- Subject : Extension-retraction unit, rear fork of spindle-drive
- Effectivity : DG-800 variants DG-800B (with spindle-drive Stross) and DG-808C
DG-500M variant DG-500MB

- Reason : To increase the fatigue life of the rear fork of the spindle drive a new fork was
designed which is milled from a steel block. This replaces the original welded fork
With DG-808C ser. no. 8-408 up to 8-410 and from ser. no. 8-412 on the fork will
be screwed directly into the push tube of the spindle drive.

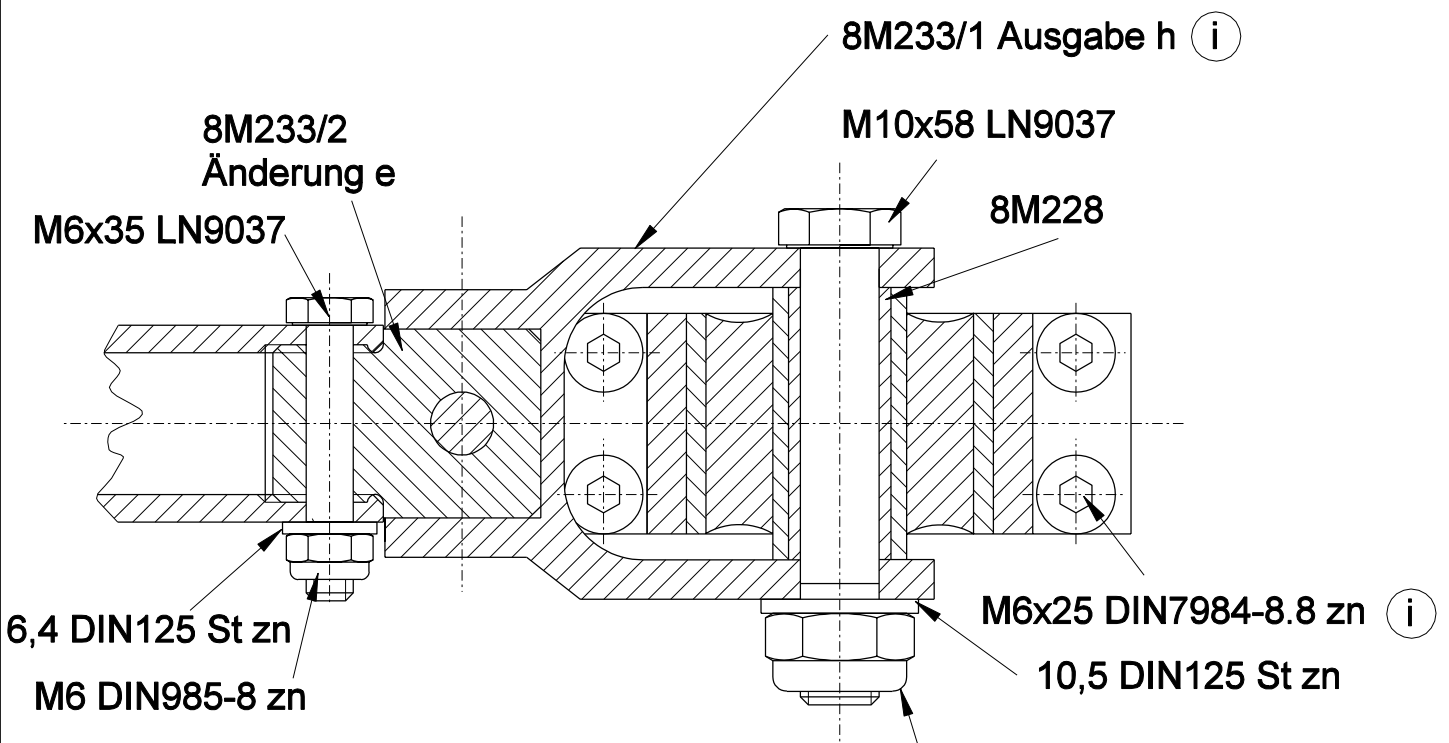
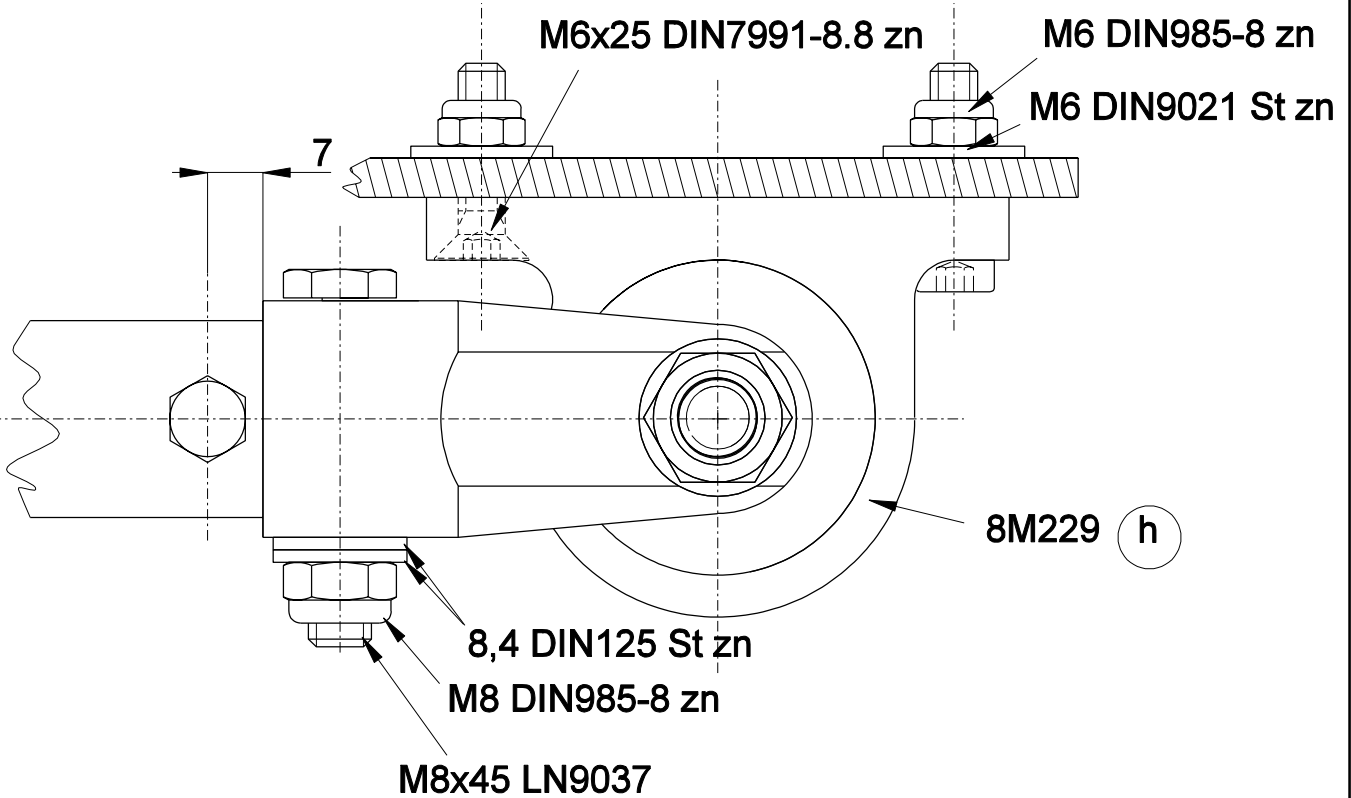
- Instructions : 1. DG-800B and DG-500MB and DG-808C up to ser. no. 8-402, ser. no. 8-404 up
to 406 and 8-410:
The fork 8M233/1 (drawing issue h) may be installed instead of the welded fork
without further modifications, but use only 1 washer between nut and fork at the
M10 bolt, see drawing 8M227 issue i.

2. With DG-808C ser. no. 8-403 and ser. no. 8-407 up to 409 and from ser. no. 8-
411 on another fork 8M333 will be used. This fork will be screwed directly into
the push tube of the spindle drive according to drawing 8M327. The adapter
8M233/2 and the bolt M8x45 LN9037 are no longer necessary.

X= Wenn 8M233 Ausgabe h als Ersatzteil
 DG-800B und DG-808C bis W.Nr. 8-402,
 8-404 bis 406 und 8-410
 DG-500MB alle W.Nr.
